**Officer South Employment Precinct Structure Plan
Draft Amendment C274card**

Victorian Planning Authority Projects Standing Advisory Committee Referral 8 Report

Officer South Employment Precinct Structure Plan

Draft Amendment C274card

Primary Arterial 6 Lane – 41m – Officer South Road with waterway interface

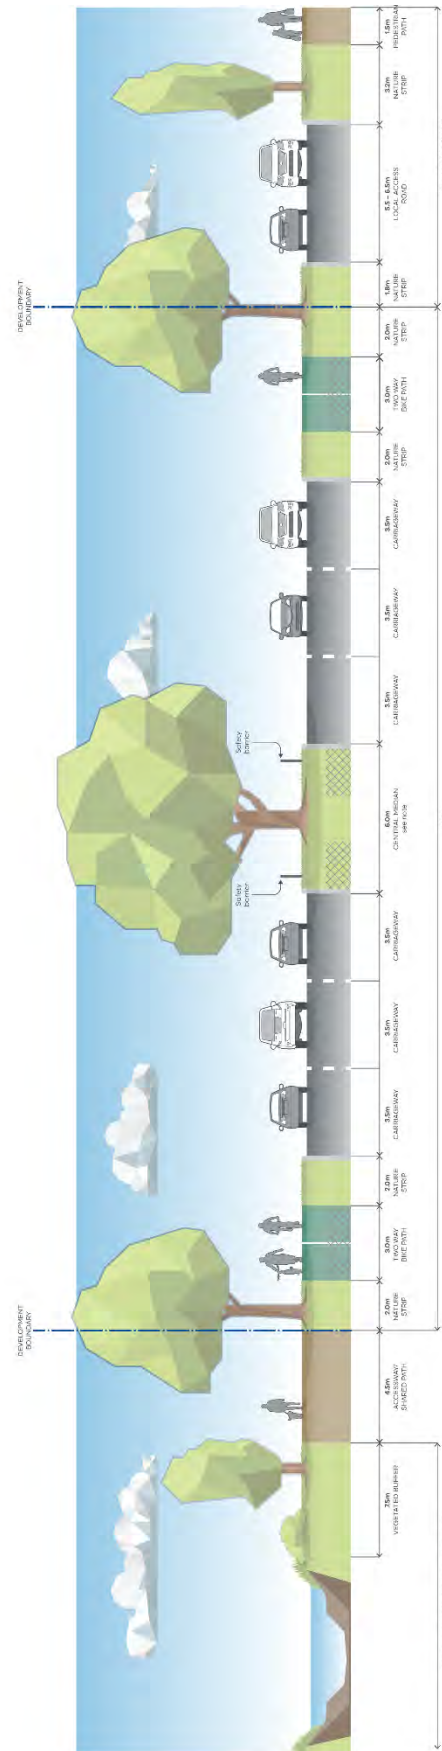
Recommendation 6(p): add notes to relevant cross sections to:

- allow for paths or shared paths to be located within either abutting public open space or the road reserve
- specify that footpaths in the town centre be 1.8 metres wide
- make it clear that the paths on either side of the primary and secondary arterials will initially be a shared path, then converted to a dedicated cycle path once the footpath is provided along the entire length of the adjoining development front.
